PROJECT **123A90 - HOLLANDSE KUST NOORD WIND PARK**
BLPH Project

MECHANICAL COMPLETION DOSSIER (ONSHORE)

Junction Box 00-JE-22001 and Multi-core cable (SIS System)

Ready For Commissioning (RFC) Certificate

C30002406

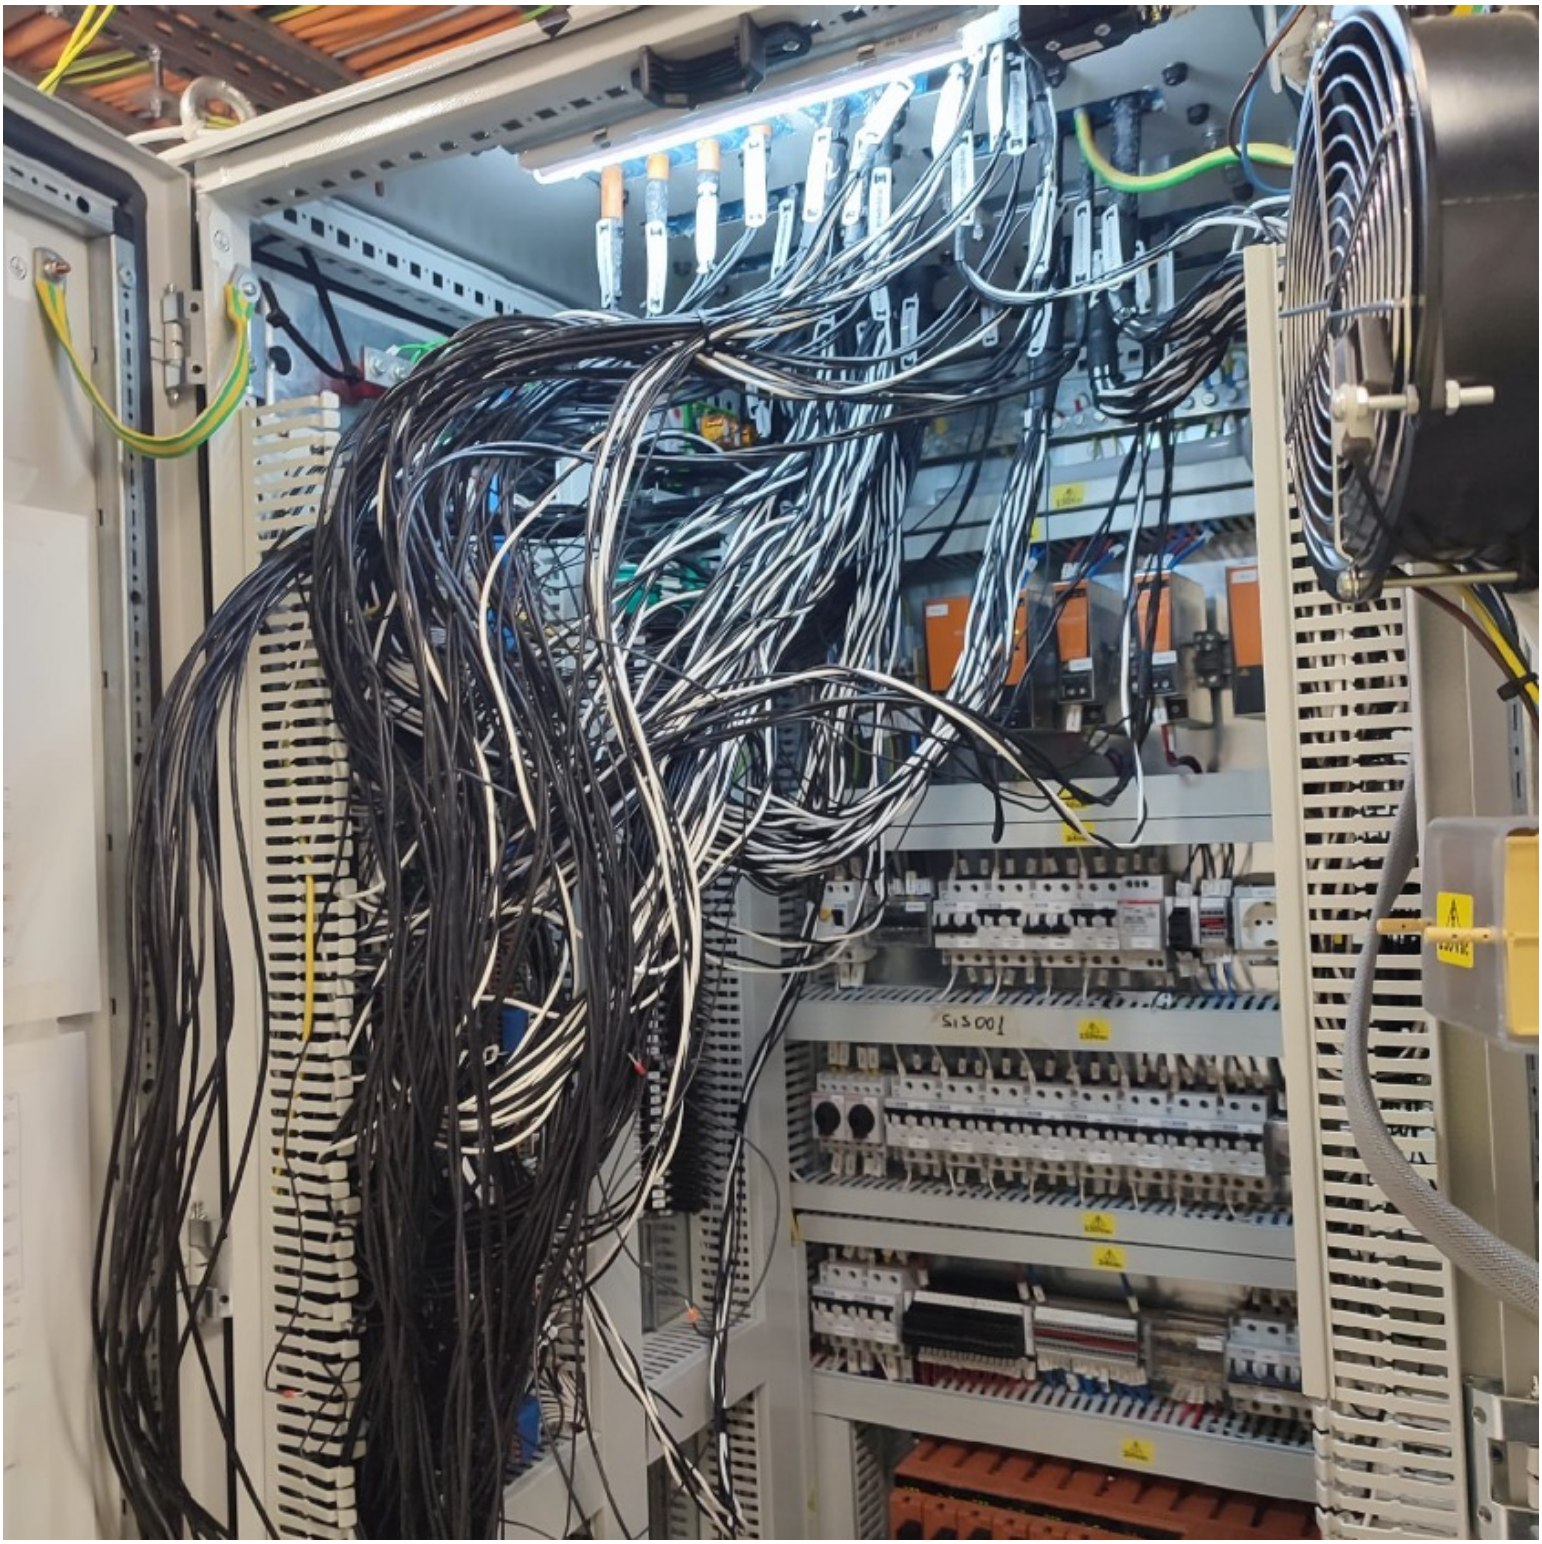
Cable must be dressed properly inside B400-SIS-001.

See attached photo.

Cable is properly dressed.

C30002388

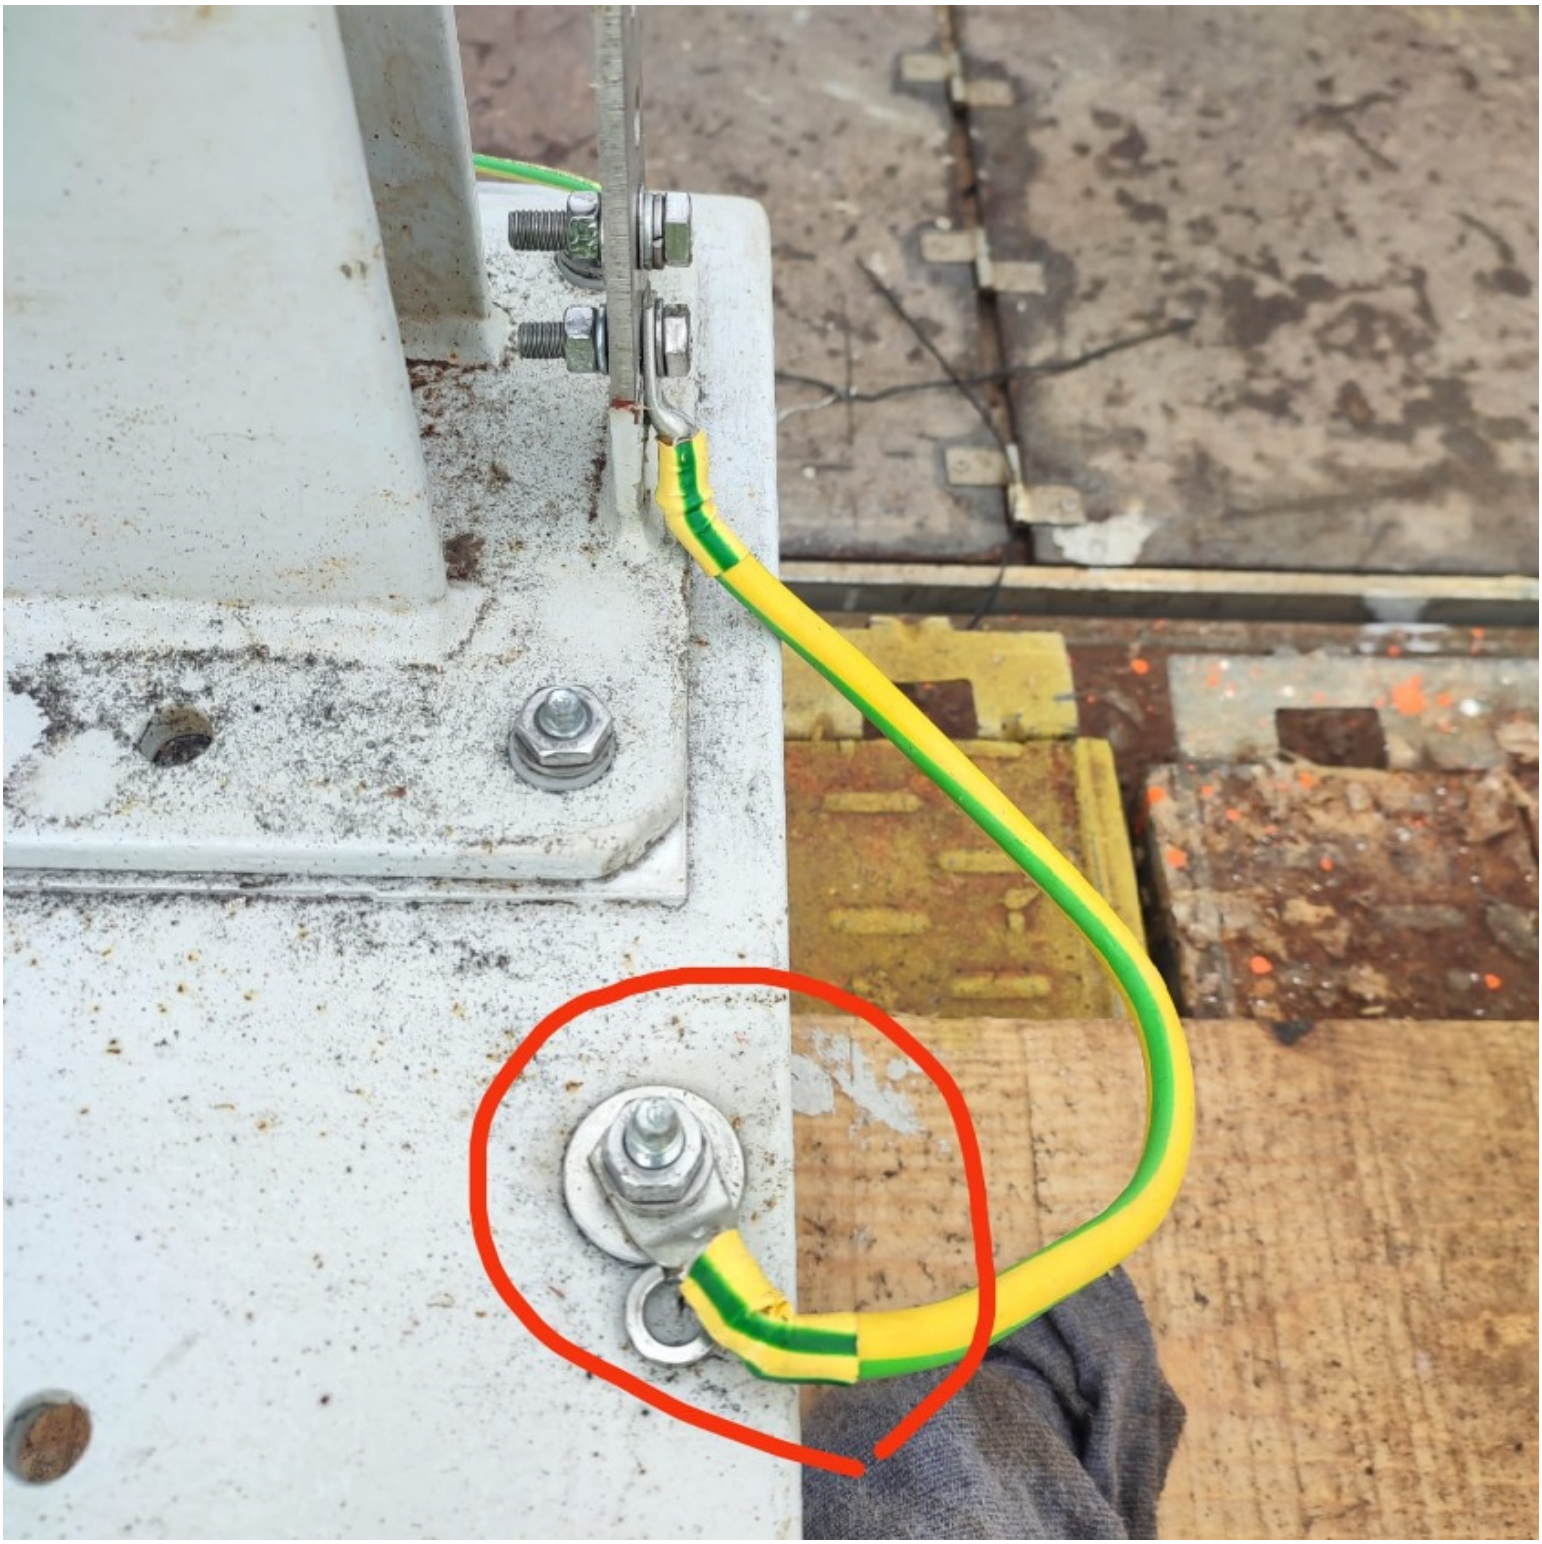
Earthing cable 35mm ON THE SUPPORT/ STRUCTURE is damage .

See attached photo.

DONE

C30002390

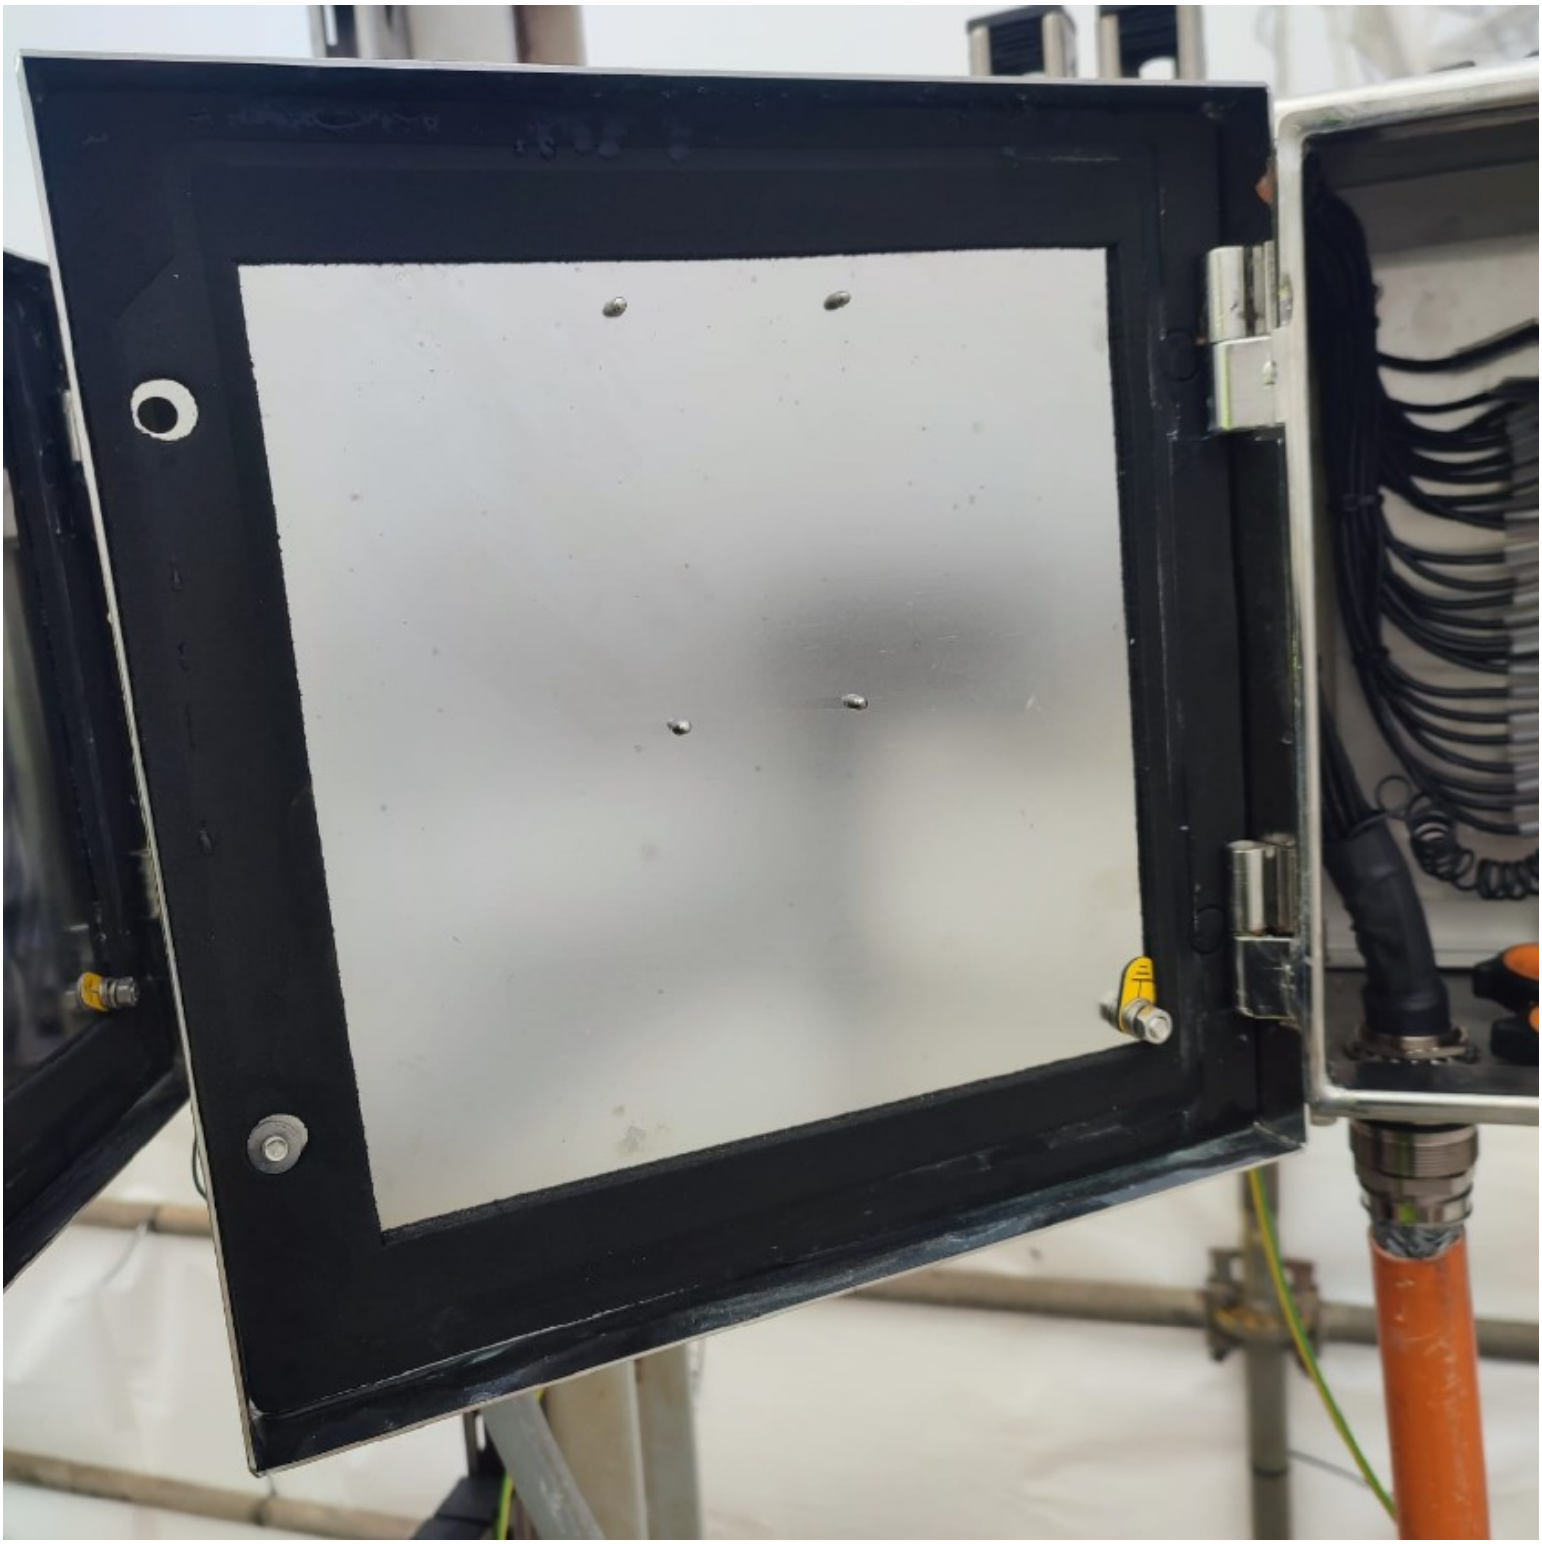
The rivets, inside the cover, must be "sealed" with suitable material.

Vendor declare that rivets used by Cortem to fix the tags on the cover of the
junction boxes series CTB have been tested and certificated to guarantee the degree
of protection of IP66.

C30002392

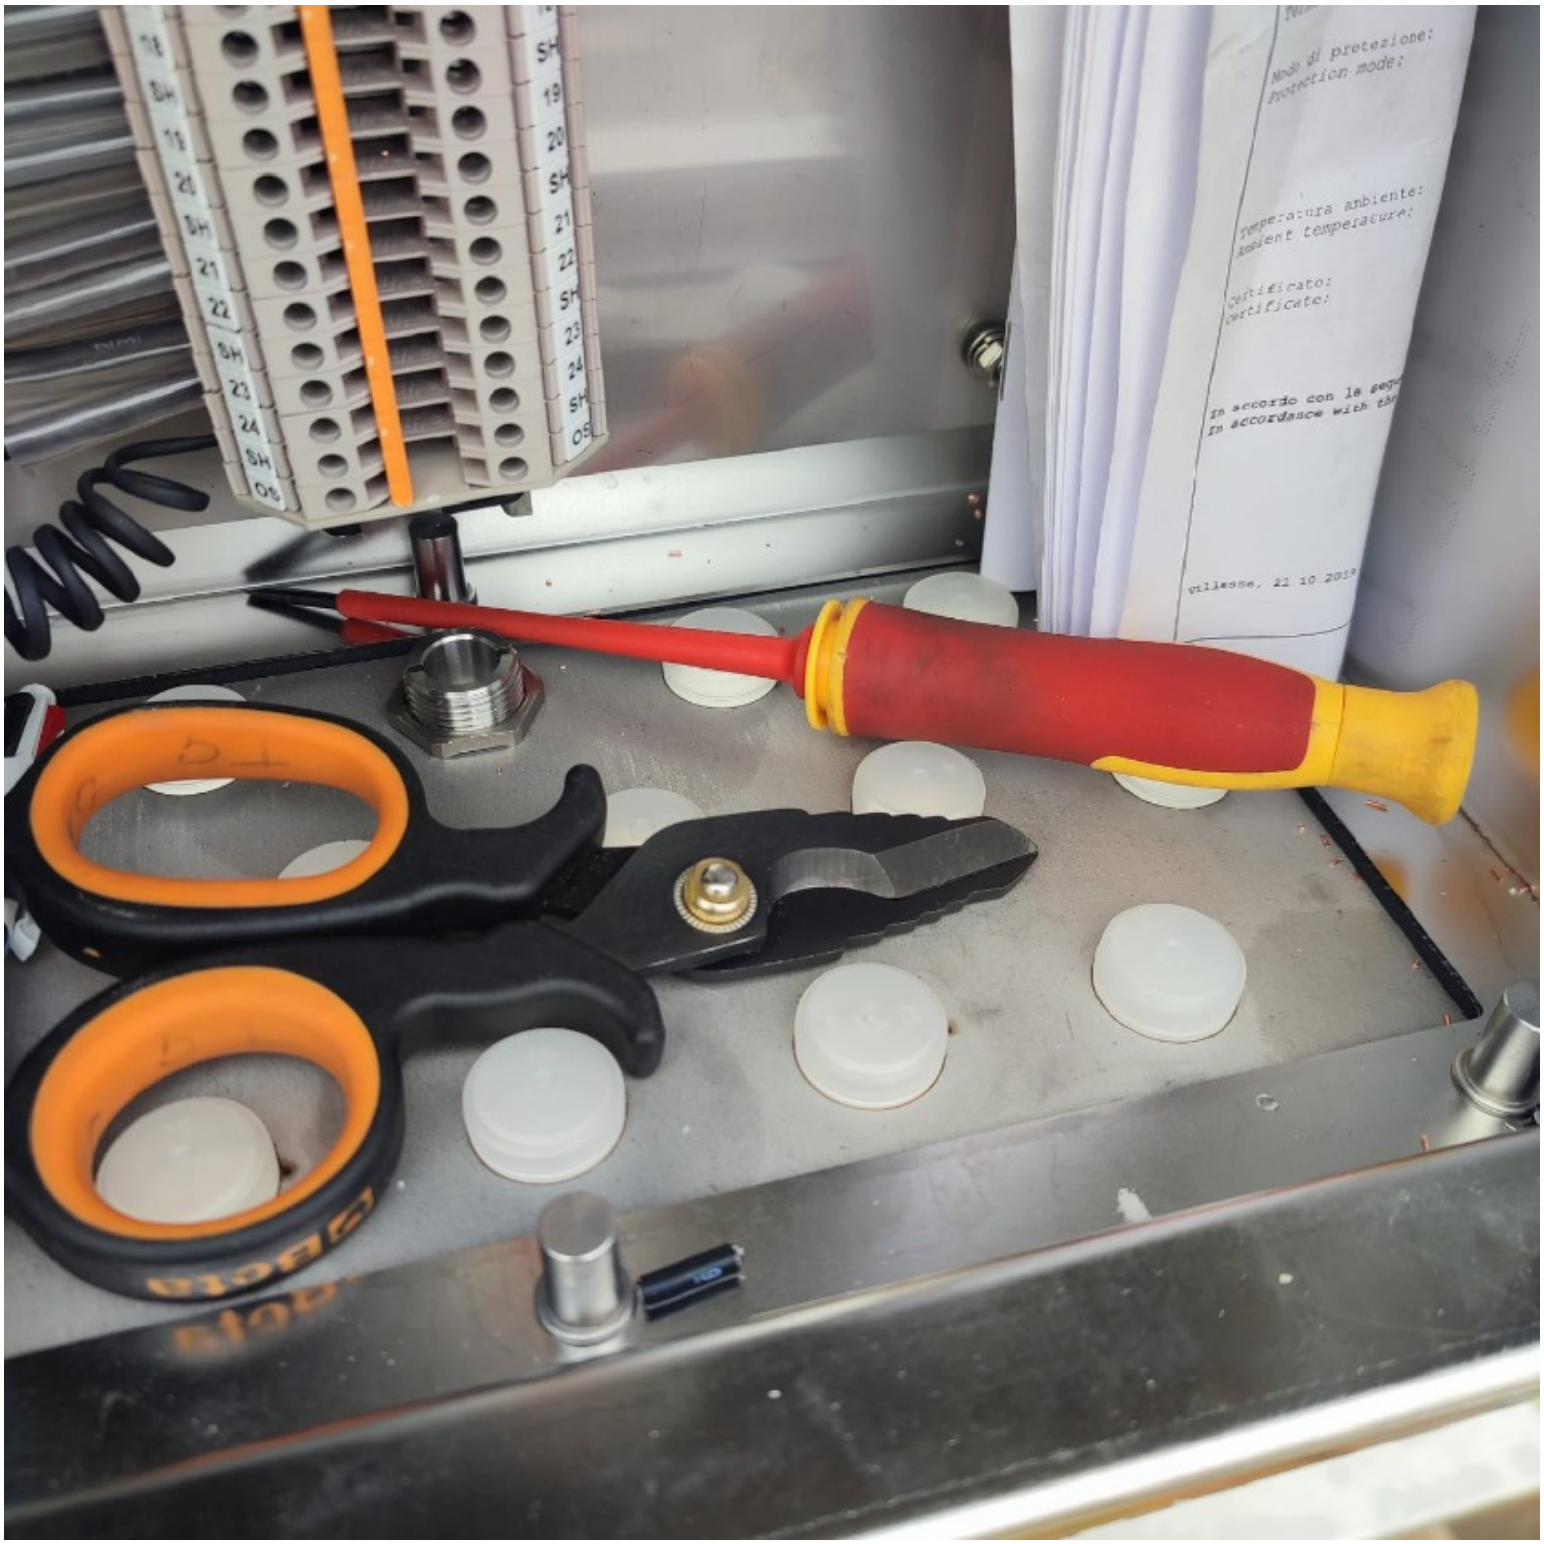
Missing internal certificate plugs on the (00-JE-22001).

See attached photo.

DONE
